**COMMONWEALTH OF KENTUCKY
TRANSPORTATION CABINET**

CALL NO. 106
CONTRACT ID NO. 171050
ADDENDUM # 2

Subject: Clay County, STP 6000 (112)
Letting December 8, 2017

- (1) Added - Special Notes - Pages 1-10 of 10
- (2) Revised - Bid Items - Pages 217-222 (a) of 222
- (3) Revised - Plan Sheets - R2L, DWG 27581 (S1, S8, S9, S11)

TITLE

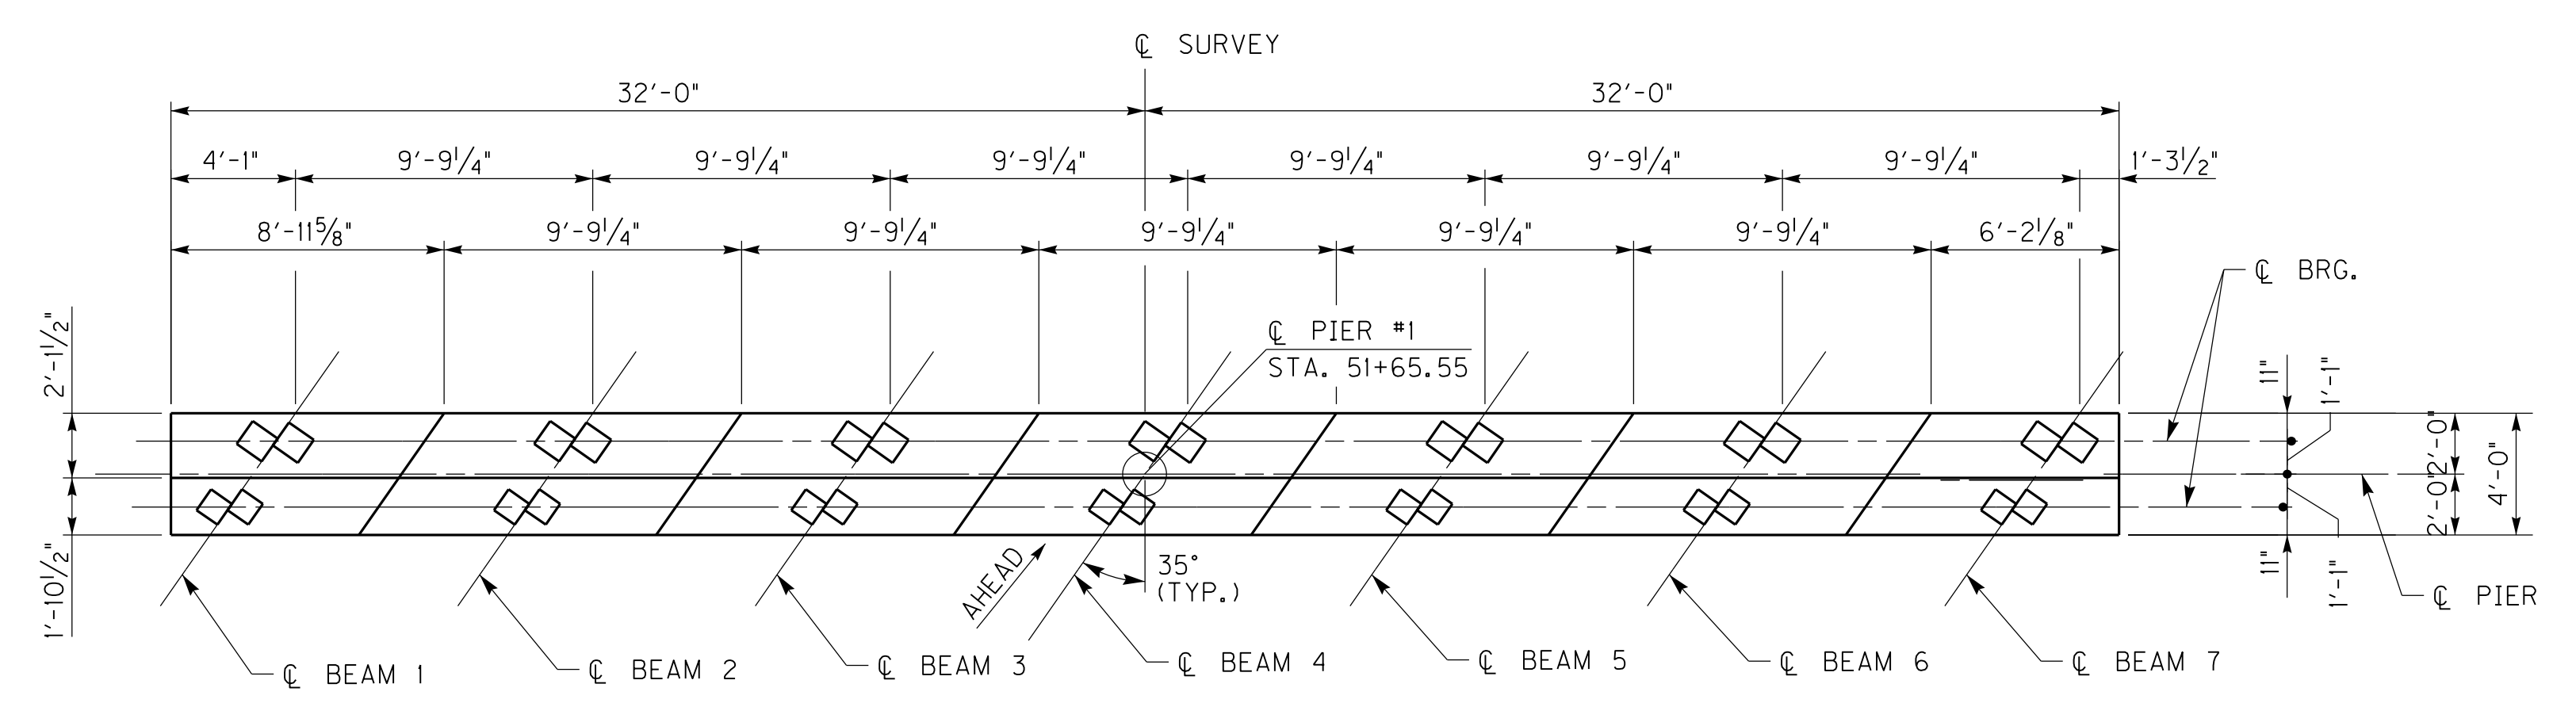
QUANTITY ADDITION/REVISION		12/01/2017
REVISION		DATE
DATE: 9-29-2017	CHECKED BY	
DESIGNED BY: D. CARPENTER	J. MILES	
DETAILED BY: J. BURT	J. MILES

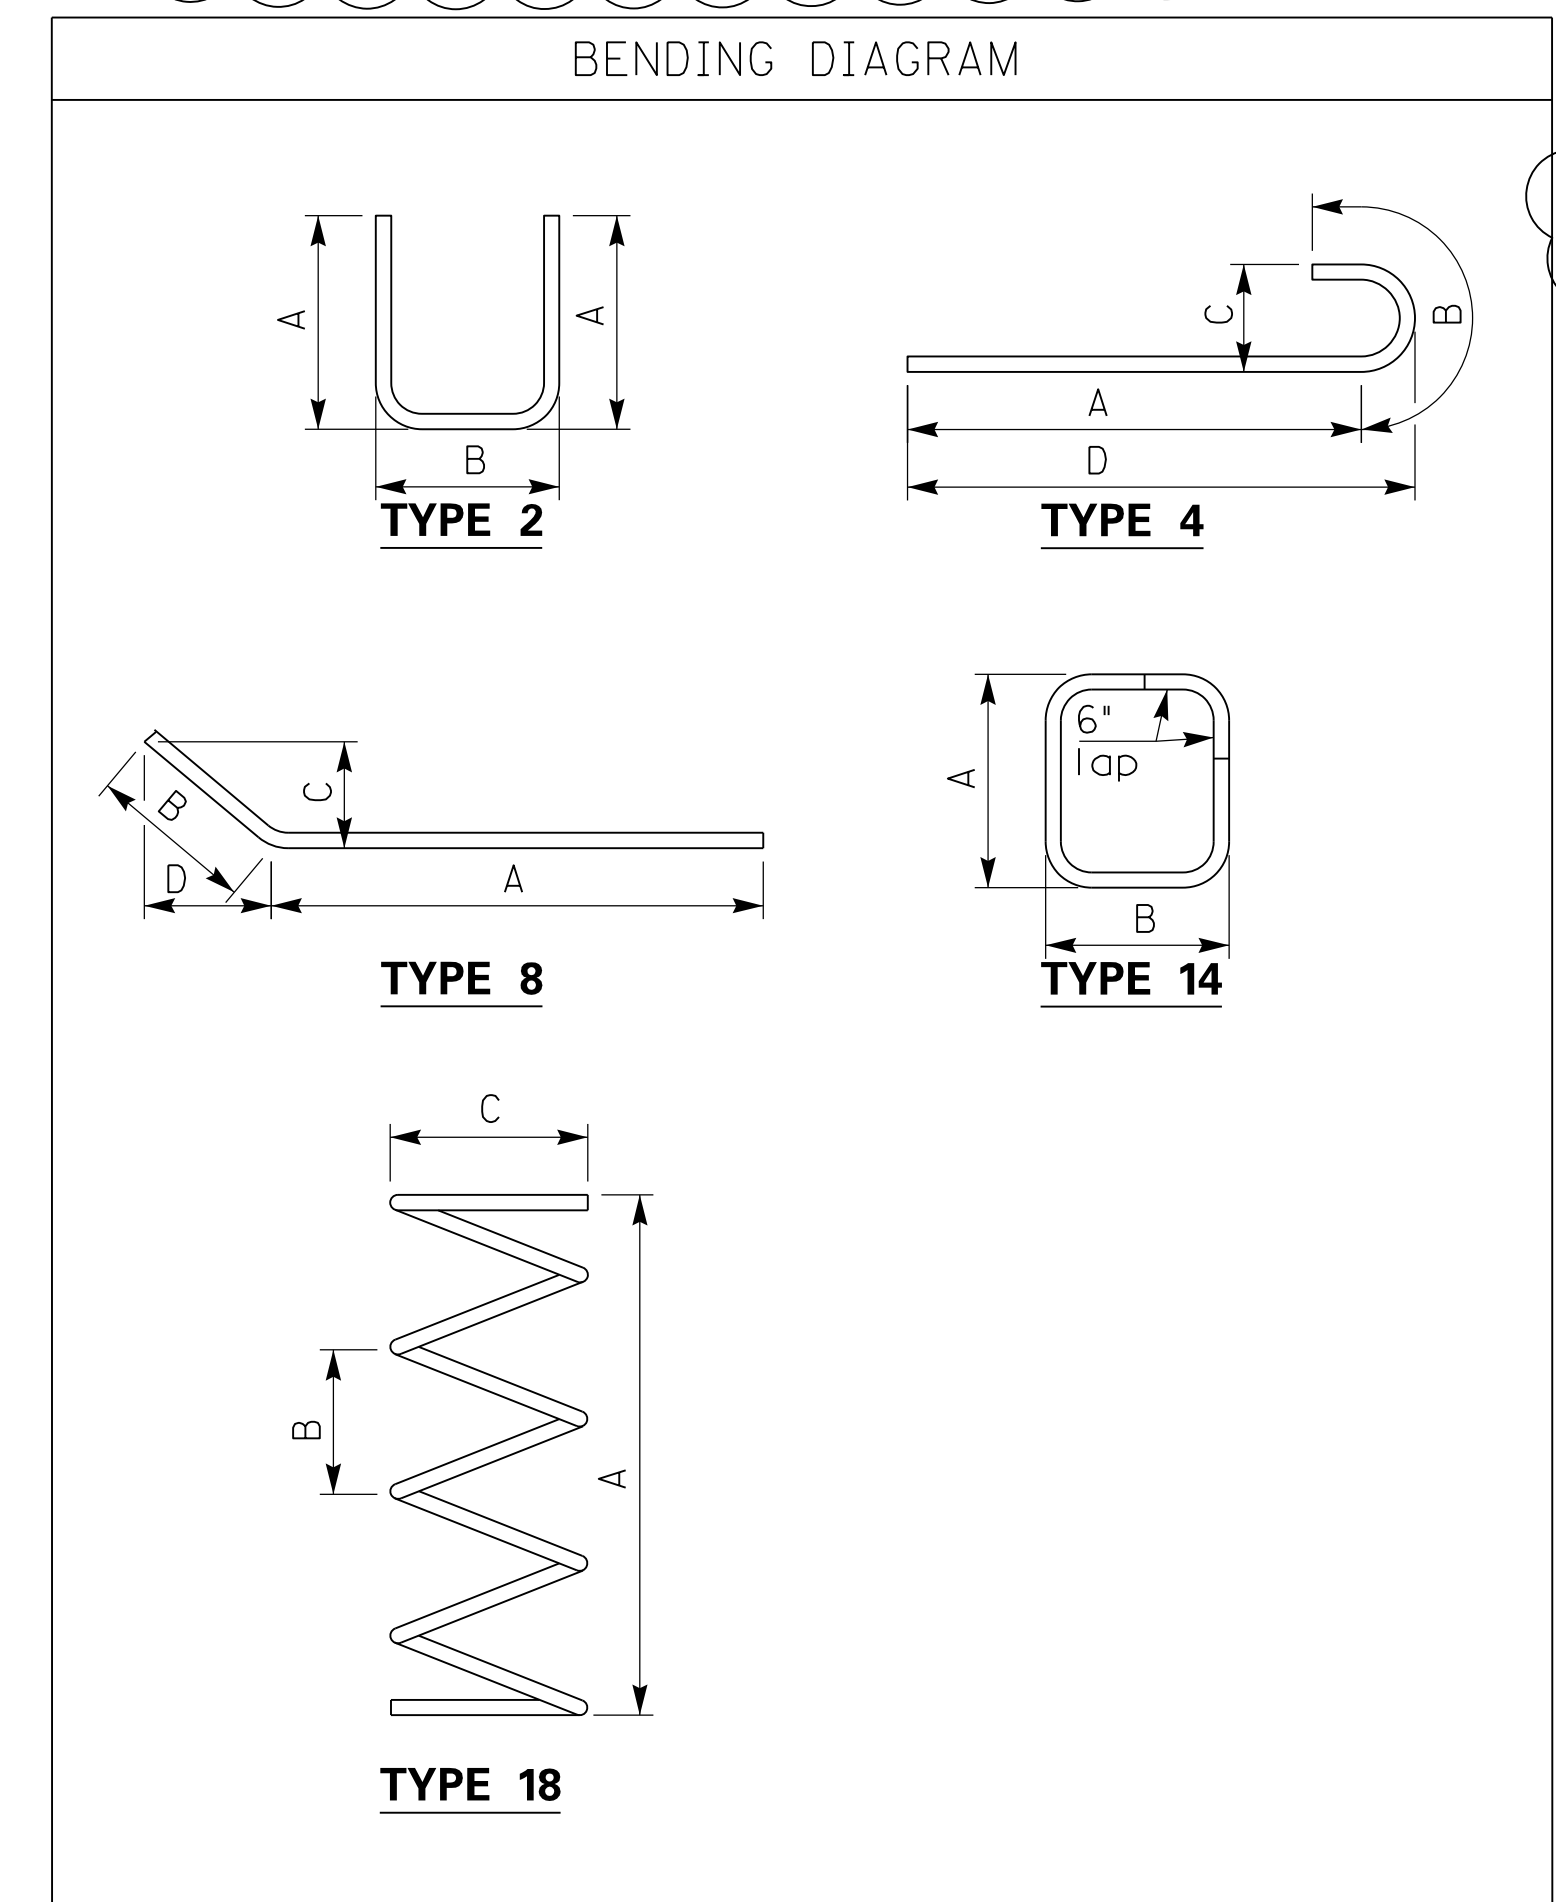
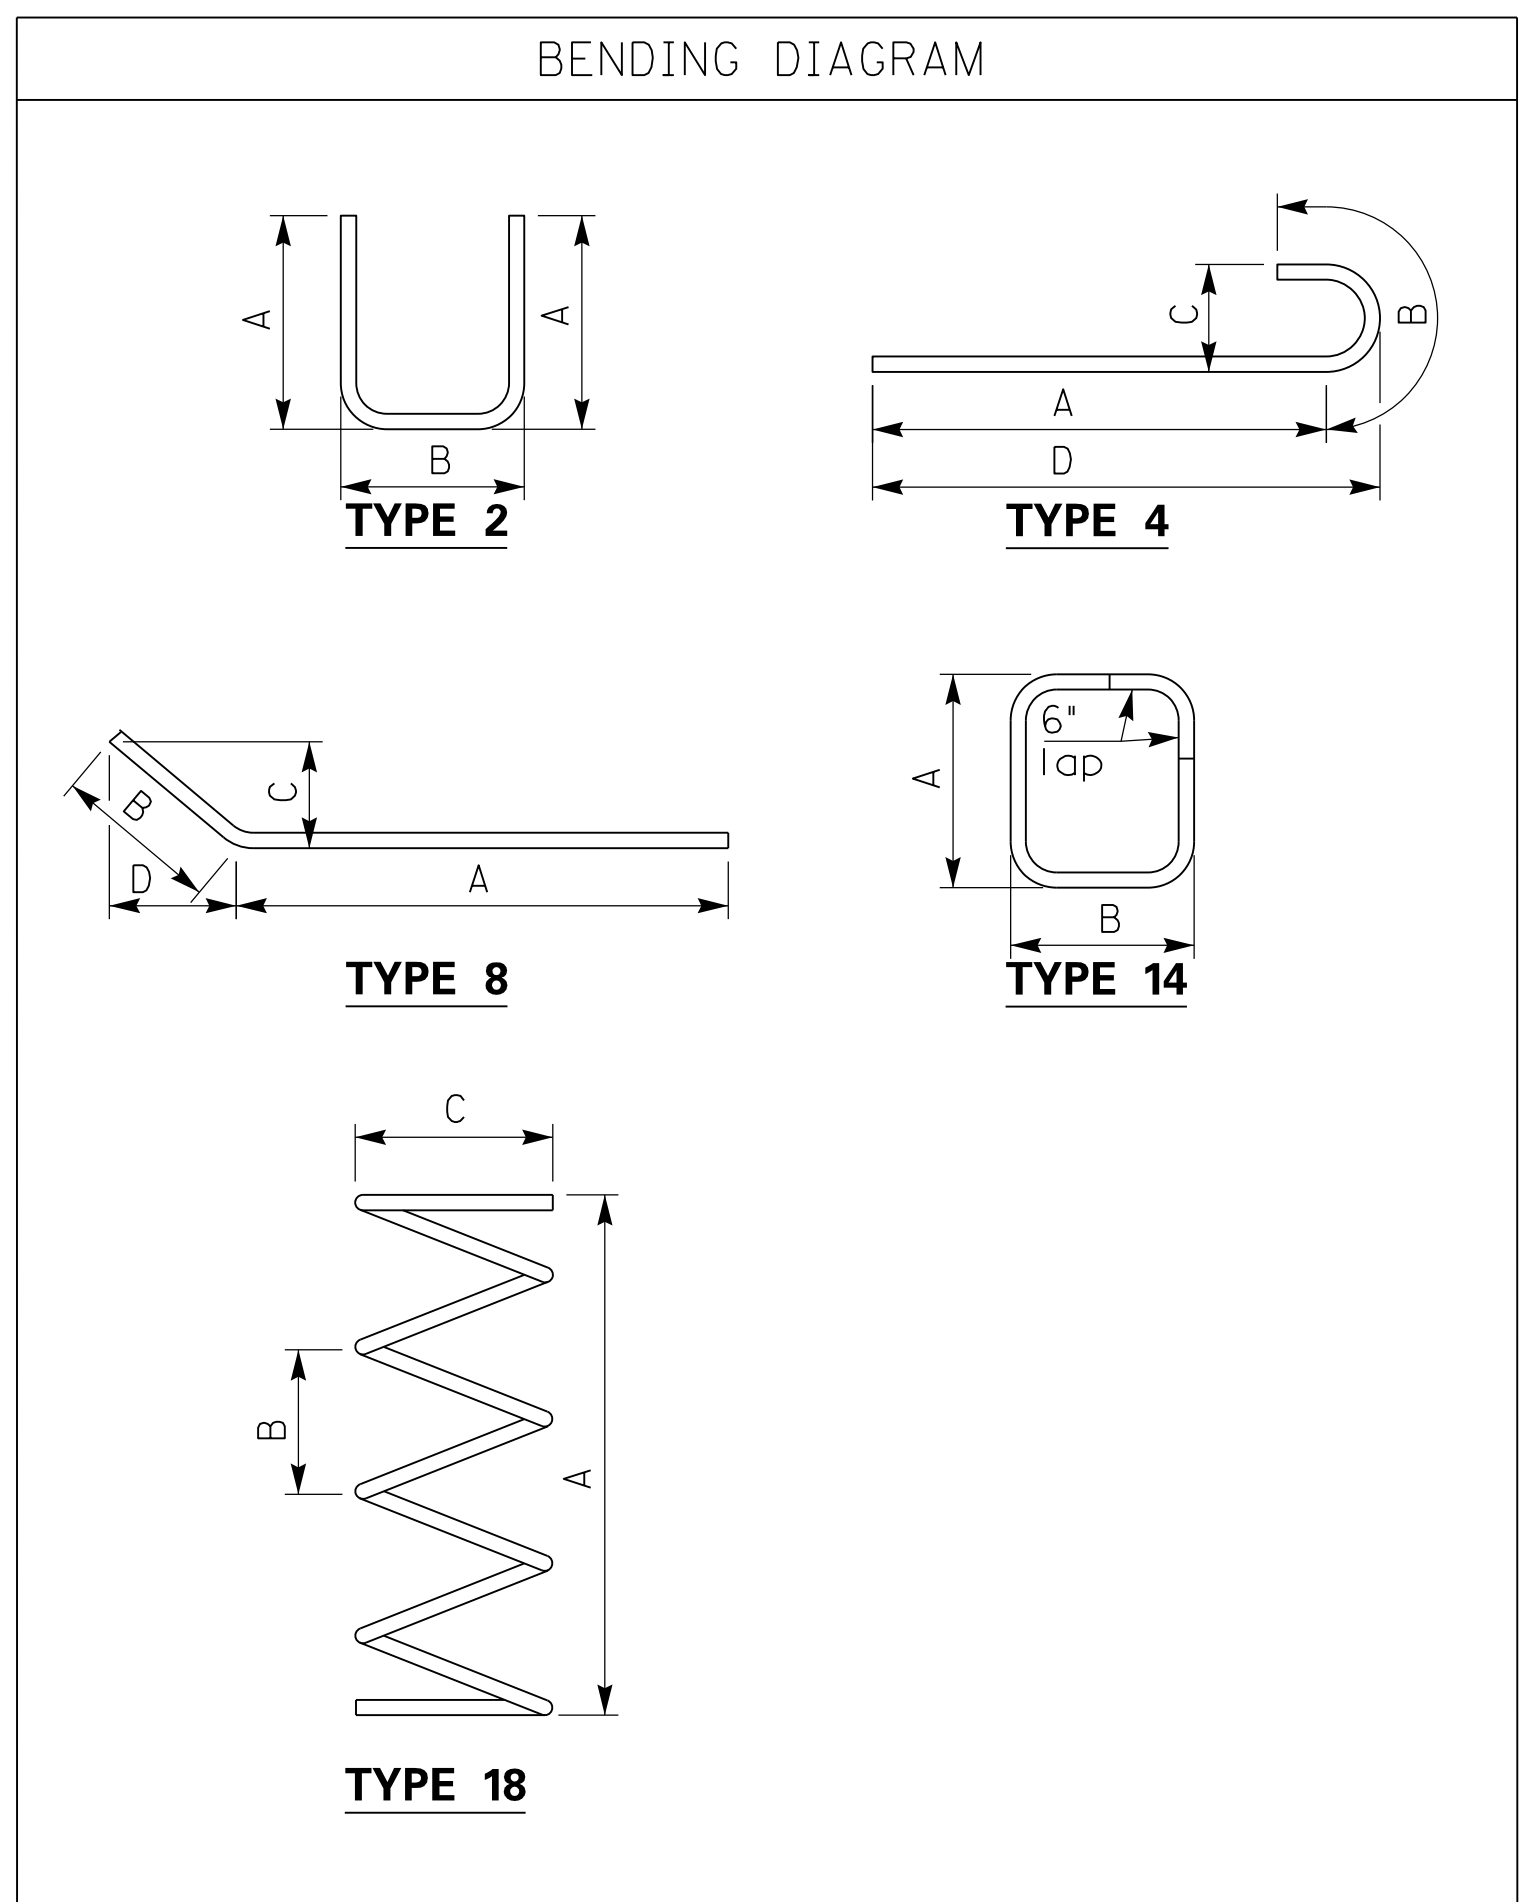
△ DRILLED SHAFT REVISION		12/01/2017
REVISION		DATE
DATE: 09/29/2017	CHECKED BY	
DESIGNED BY: D. CARPENTER	J. MILES	
DETAILED BY: J. BURT	J. MILES	
Commonwealth of Kentucky		
DEPARTMENT OF HIGHWAYS		
COUNTY		
CLAY		
ROUTE	CROSSING	
KY 2432	GOOSE CREEK	
SUBSTRUCTURE REINFORCEMENT		
ITEM NUMBER	PREPARED BY	SHEET NO.
11-8001	2500 Nelson Miller Parkway Louisville, KY 40223 (502) 245-3813	S11
	AMERICAN ENGINEERS, INC. PROFESSIONAL ENGINEERING	DRAWING NO.
	www.aei.cc	27581

△ DRILLED SHAFT REVISION		12/01/2017
REVISION		DATE
DATE: 09/29/2017	CHECKED BY	
DESIGNED BY: D. CARPENTER	J. MILES	
DETAILED BY: J. BURT	J. MILES	
Commonwealth of Kentucky		
DEPARTMENT OF HIGHWAYS		
COUNTY		
CLAY		
ROUTE	CROSSING	
KY 2432	GOOSE CREEK	
SUBSTRUCTURE REINFORCEMENT		
ITEM NUMBER	PREPARED BY	
11-8001	2500 Nelson Miller Parkway Louisville, KY 40223 (502) 245-3813	
	SHEET NO. S11	
	DRAWING NO. 27581
